SUBJECT: SEQUOYAH NUCLEAR PLANT, UNITS 1 AND 2 - STAFF ASSESSMENT OF INFORMATION PROVIDED PURSUANT TO TITLE 10 OF THE *CODE OF FEDERAL REGULATIONS* PART 50, SECTION 50.54(f), SEISMIC HAZARD REEVALUATIONS RELATING TO RECOMMENDATION 2.1 OF THE NEAR-TERM TASK FORCE REVIEW OF INSIGHTS FROM THE FUKUSHIMA DAI-ICHI ACCIDENT (TAC NOS. MF3767 AND MF3768)

STAFF ASSESSMENT BY THE OFFICE OF NUCLEAR REACTOR REGULATION

RELATED TO SEISMIC HAZARD AND SCREENING REPORT

SEQUOYAH NUCLEAR PLANT, UNITS. 1 AND 2

Figure 3.3-1 Plot of Staff's and Licensee's Base Case Shear-Wave Velocity Profiles for the Sequoyah site

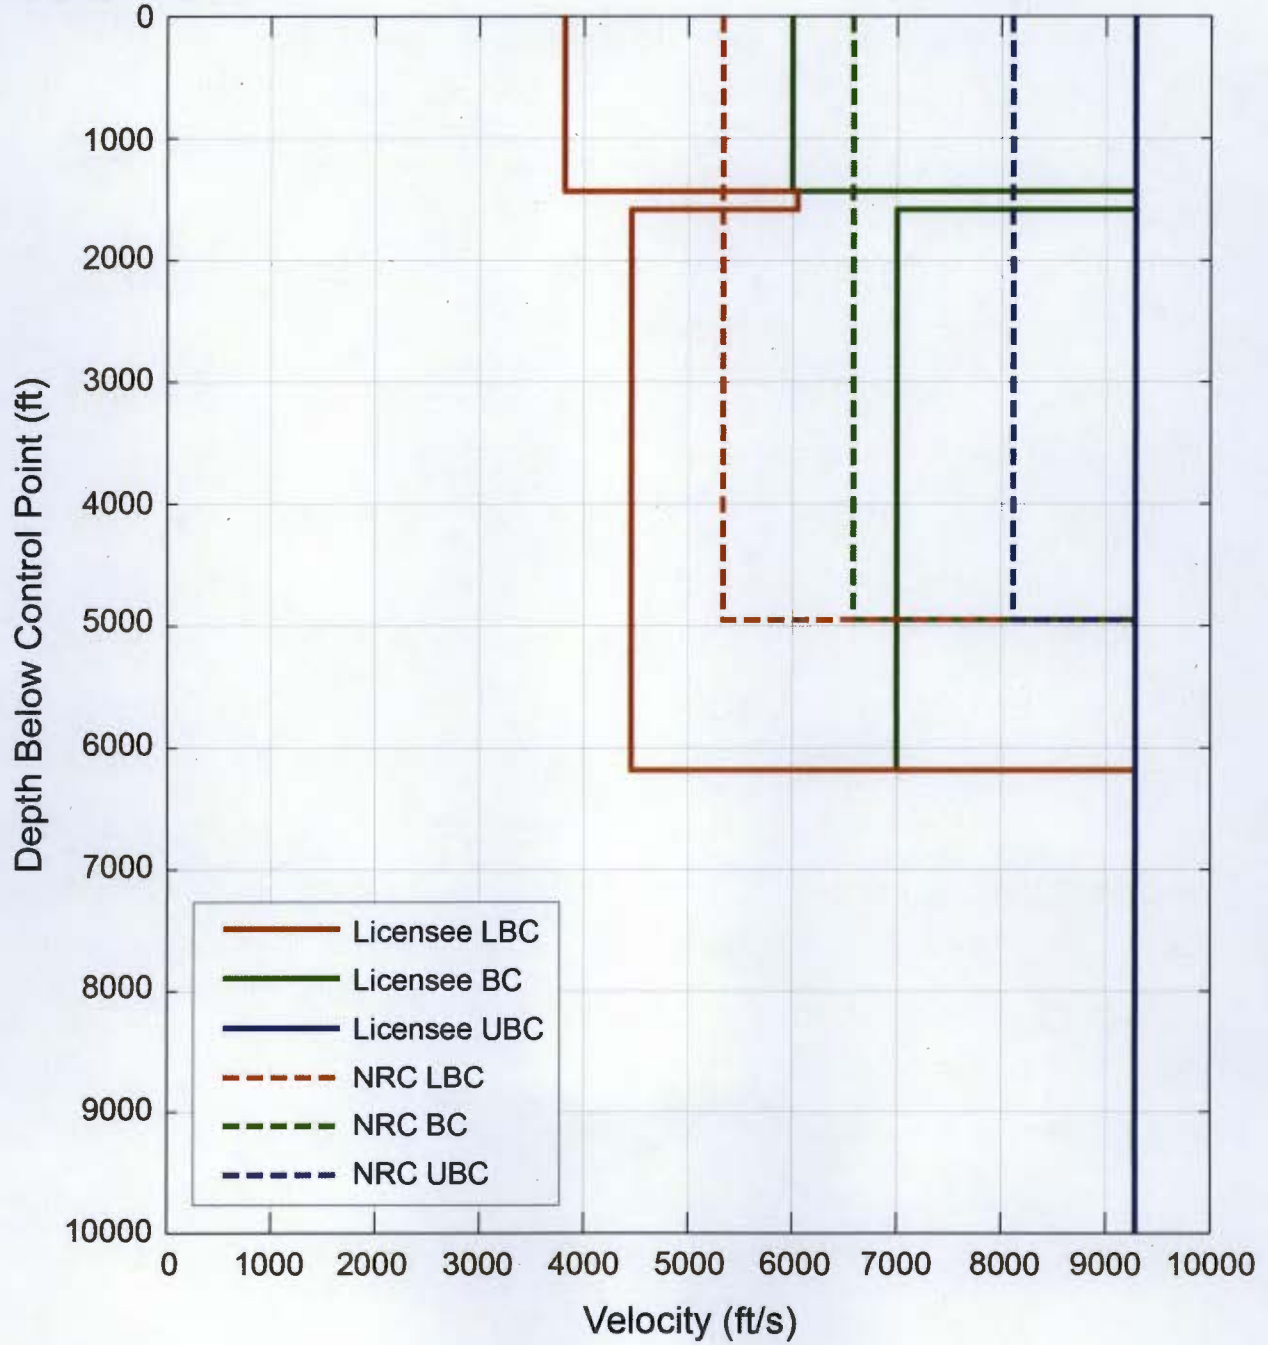
The NRC staff developed three velocity profiles based on the up-hole and cross-hole shear-wave velocity measurements at the site as reported in the FSAR (TVA, Amendment 24, Tables 2.5.1-1 and 2.5.1-2). An investigation of the distribution of these measurements indicate nearly lognormal behavior with a median of 6,567 ft/s [2,002 m/s], and a natural-log standard deviation of 0.164. The NRC staff used these values to develop a set of three velocity profiles from the control point to a depth of 5,000 ft [1,524 m] above reference rock. Figure 3.3-1 of this assessment shows a comparison between the staff's and the licensee's base case profiles. The mean base-case velocity profile of the NRC staff is similar to that of the licensee. For the upper and lower base-case velocity profiles, the licensee used a scale factor of 1.57 (a natural-log standard deviation of 0.35) to reflect its understanding of the uncertainty. In contrast, the staff used a factor of 1.23 (a natural-log standard deviation of 0.164), to obtain the upper and lower base cases profiles, which reflects the staff's interpretation of potential variability in the firm sedimentary rock layers beneath the site.

Figure 3.3- 1 Plot Comparing the Staff's and the License's Median Amplification Functions and Uncertainties for the Sequoyah site

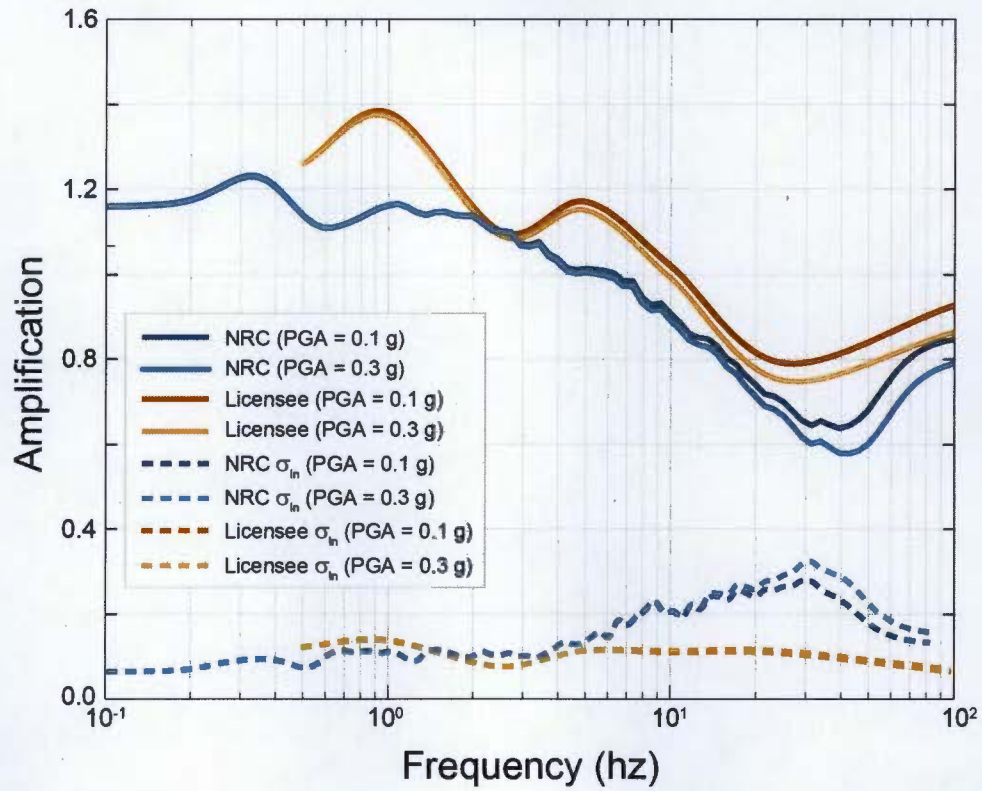
Figure 3.3-2 of this assessment shows a comparison of the staff's and the licensee's median site amplification functions and uncertainties for two of the eleven input loading levels. As shown in this figure, the licensee's amplification functions are somewhat higher than those of the staff's. These small differences in the amplification functions reflect the minor differences in the site response analyses performed by the staff and the licensee. These small differences are within the limits of uncertainty and as such judged by the staff to be reasonable.

Figure 3.4-1 Comparison of the Staff's GMRS, Licensee's GMRS, and the SSE for the Sequoyah site

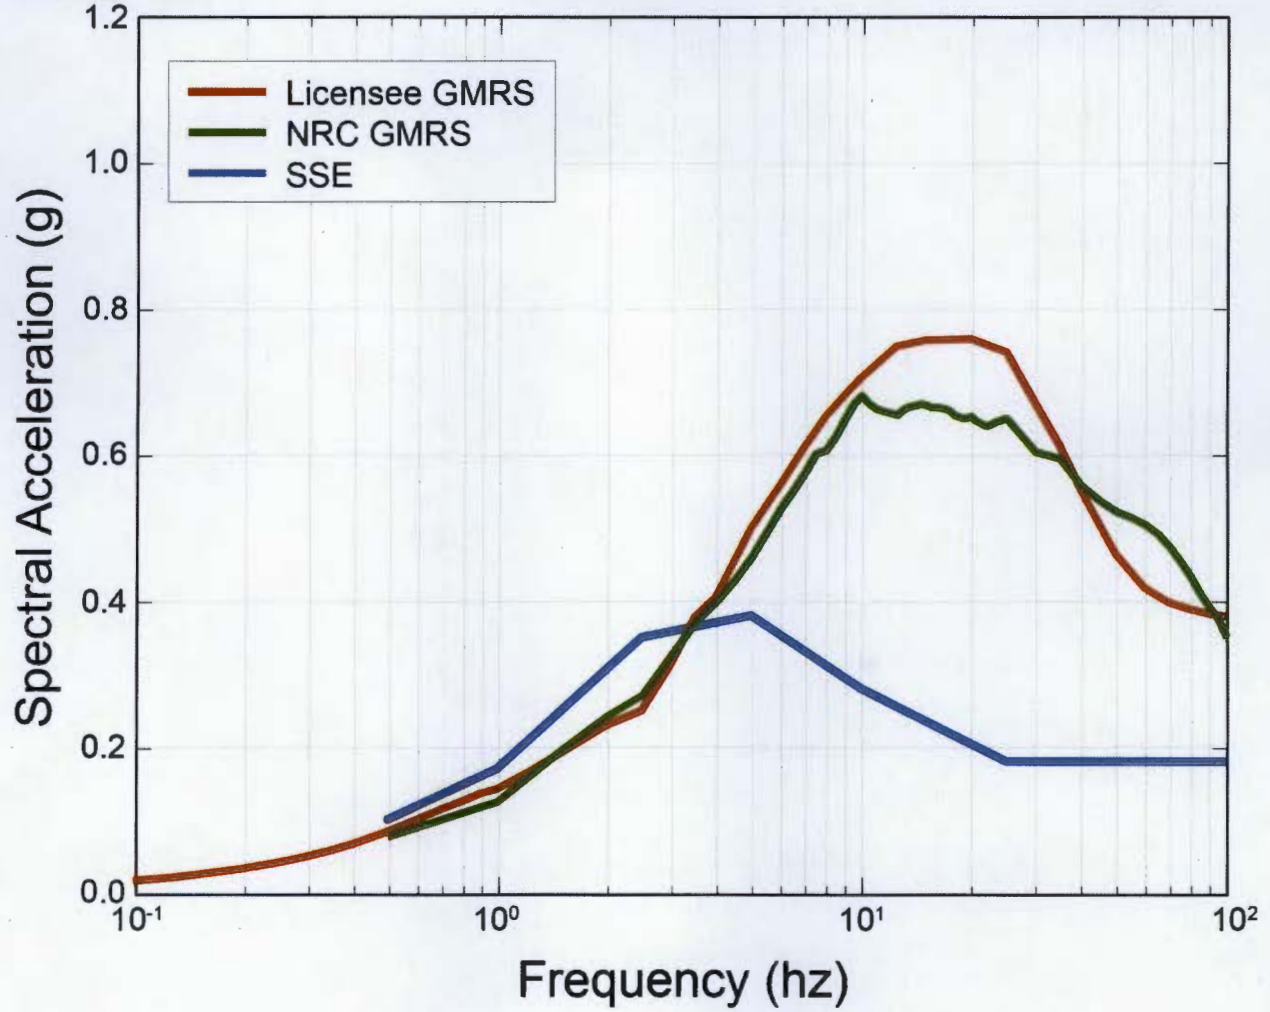
The staff independently calculated the 10^{-4} and 10^{-5} UHRS using the results of its confirmatory PSHA and site response analyses, as described in Sections 3.2 and 3.3 of this assessment, respectively. Figure 3.4-1 of this assessment shows a comparison of the GMRS determined by the licensee to that determined by the staff.

As shown in Figure 3.4-1, the licensee's GMRS shape is generally similar to that calculated by the staff at frequencies less than 10 Hz. However, NRC staff's confirmatory GMRS is somewhat lower than the licensee's in the 10-35 Hz range, and slightly higher above 40 Hz. As described in Section 3.3 of this assessment, the staff concludes that these minor differences over the higher frequency range are primarily due to the differences in the site response analyses performed by the licensee and staff. The staff concludes that these differences are acceptable because the licensee followed the guidance provided in the SPID with respect to both the PSHA and site response analysis for the Sequoyah site.

The staff confirms that the licensee used the present-day guidance and methodology outlined in RG 1.208 and the SPID to calculate the horizontal GMRS, as requested in the 50.54(f) letter. The staff performed both a PSHA and site response confirmatory analysis and achieved results consistent with the licensee's horizontal GMRS. As such, the staff concludes that the GMRS determined by the licensee adequately characterizes the reevaluated hazard for the Sequoyah site. Therefore, this GMRS is suitable for use in subsequent evaluations and confirmations, as needed, for the response to the 50.54(f) letter.
